File Number: 14961

APPLICATION FOR A RESIDENTIAL SITE IMPROVEMENT PERMIT/ CONSTRUCTION AUTHORIZATION FOR AN ON-SITE WASTEWATER SYSTEM, NEW WELL INSTALLATION, OR REPAIR OF EXISTING WELL

TAX PARCEL NUMBER: 13905117
STREET ADDRESS: 8906 Glencroft Road
CITY: Mint Hill
STATE: NC ZIP: 28227
SUBDIVISION NAME: Glencroft
LOT #: 10 LOT SIZE (acres): 0.57

IMPROVEMENT PERMIT for a RESIDENTIAL ON-SITE WASTEWATER TREATMENT & DISPOSAL SYSTEM

Sketch of Soil Evaluation Locations

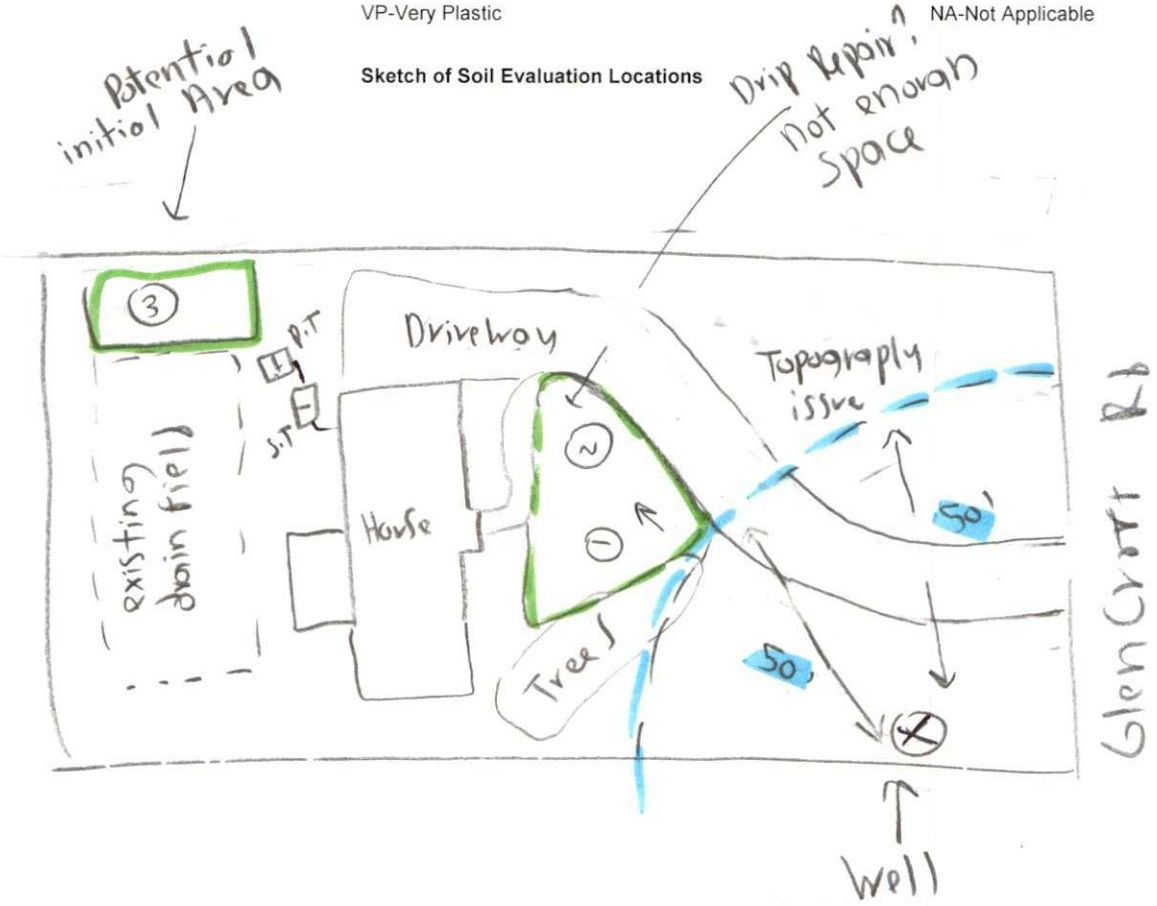
Not enough space to design 1 bedroom septic repair (lot deeded prior to 1983)
Due to soil depth/slope correction, bumps repair system to drip irrigation.
Unable to design the required square footage

Reference: 8906 Glencroft Road; Glencroft Lot 10;
PID 13905117
Mecklenburg County, NC

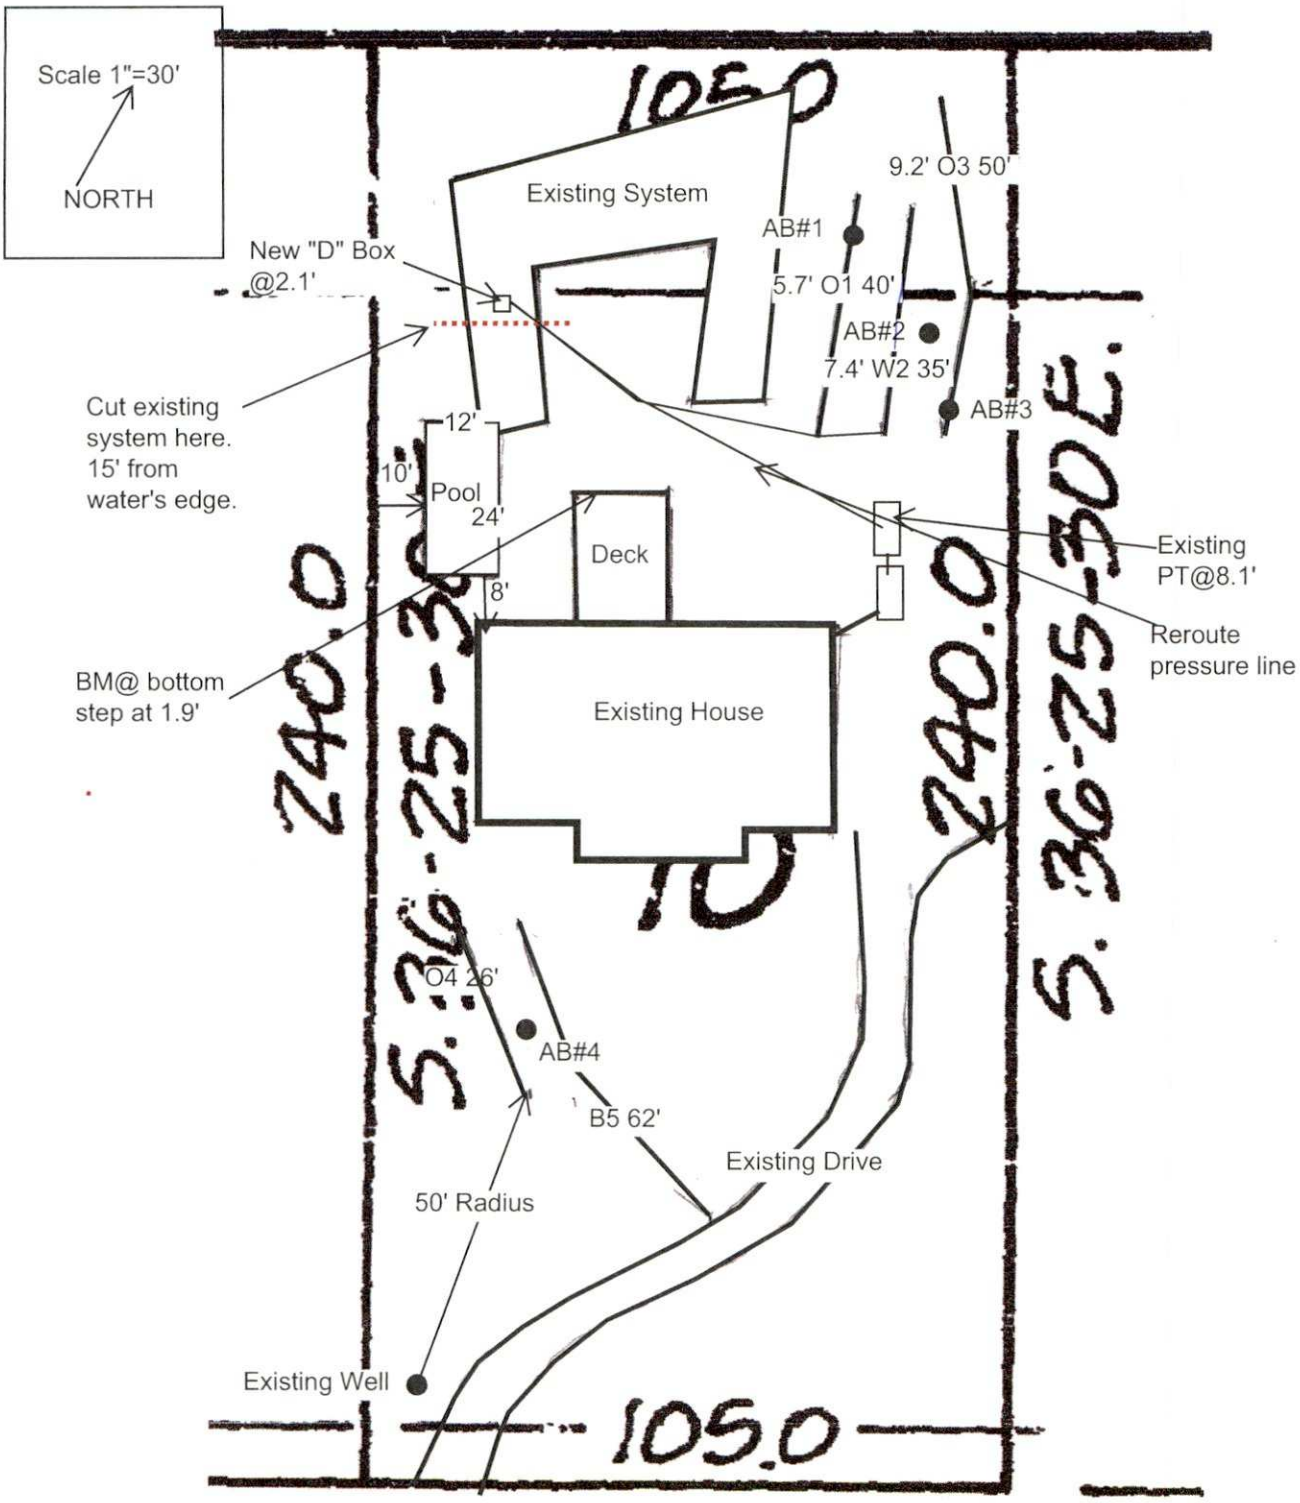
<u>Comments:</u> The purpose of this evaluation is to modify the existing system to allow for the construction of a pool.

- MA&A is proposing to alter the existing system to allow the construction of a pool. The existing system should be cut 15' from the water's edge. This results in approximately 160ft2 being removed from the existing system.

- The square footage lost is being proposed as 25% reduction downhill of the existing system. 225 ft2 is being proposed.
- **The cut edge of the existing system should be sealed with bentonite to prevent any bleed through.**

- A gate valve should be installed just before the "D" box on the pressure line to be able to control the flow of effluent into the "D" box.
- A new "D" box should be installed in the area shown on the site plan. The existing system should be fed first and then the new 25% reduction. Speed levelers should be used to allow the existing bed to fill up first before spilling over into the new 25% reduction.

- The pressure line should be re-routed to the new "D" box.

Initial System: Existing Bed plus 75' 25% Reduction **Repair System:** 138' 25% Reduction
Pump Tank: 8.1' **BM:** 1.9' see site plan

On-site Wastewater Improvement Permit Diagram

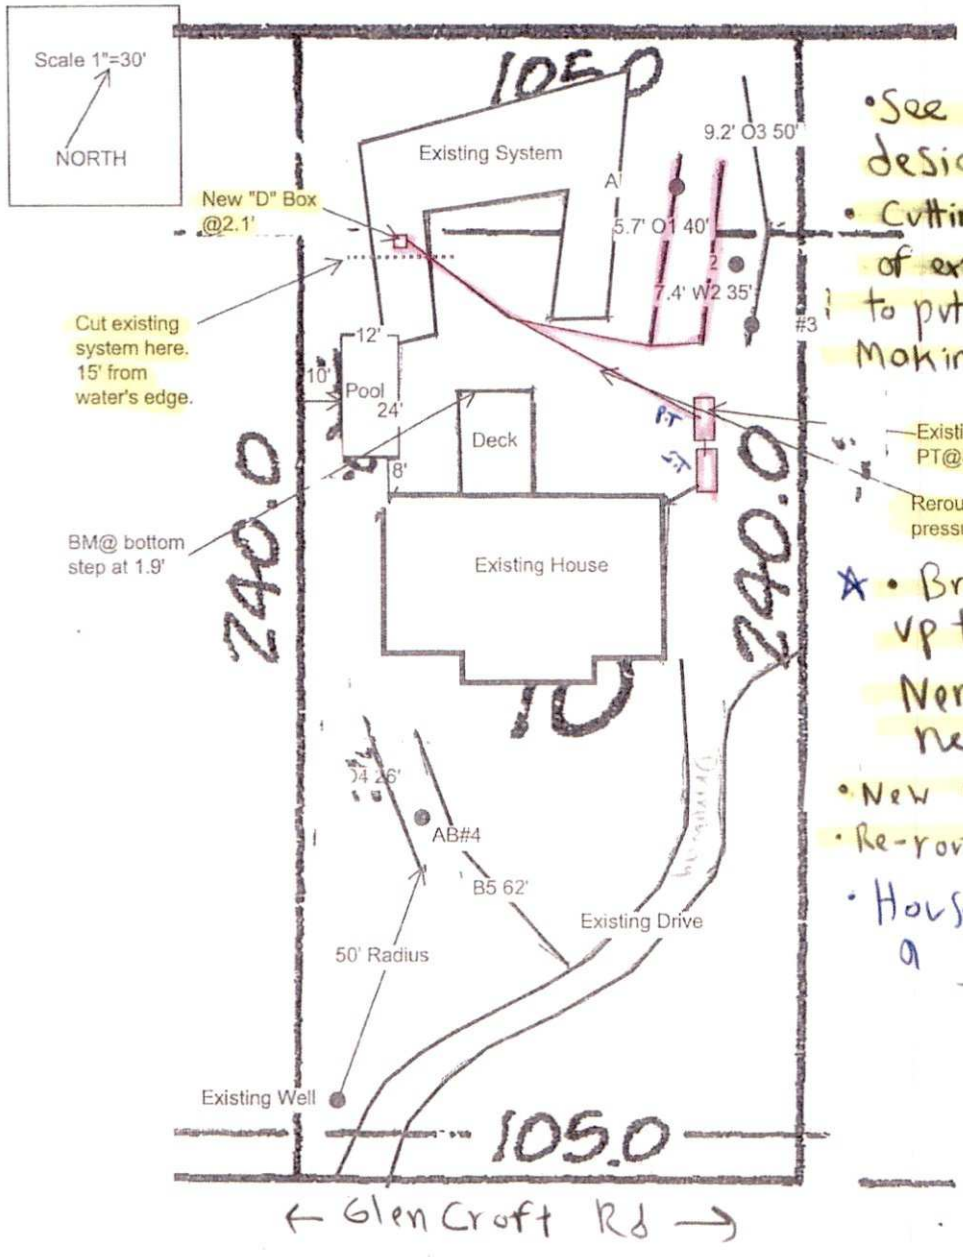
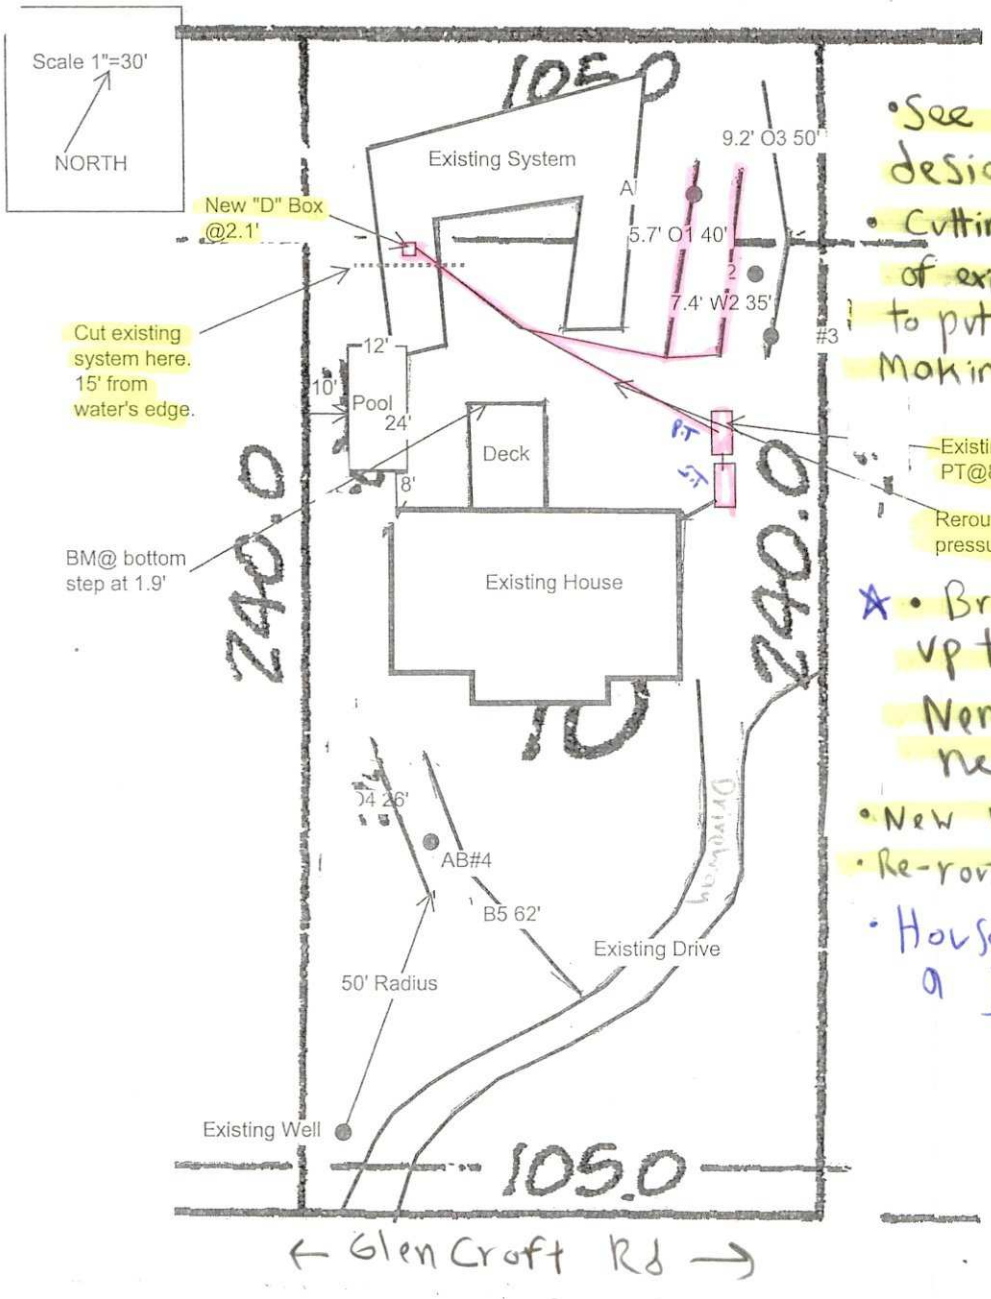
- See Attached LSS design for specifics
- Cutting off section of existing drainfield to put in a pool, making up sq. footage by adding 75' of Accepted Line
- ★ Bring pump tank up to today's standards Nema 4x box needed.
- New D-Box
- Re-route pressure Line
- House is staying a 3 Bedroom

- Flow from all gutters and downspouts shall be directed not to discharge water onto or across any part of the septic system.
- Cutting ooff a portion of the existing bed, to install a pool. Replacing the cut off portion of the bed with accepted 75' of line. LSS desing attached

- Bring P.T up to today's standard. Noma 4x box required
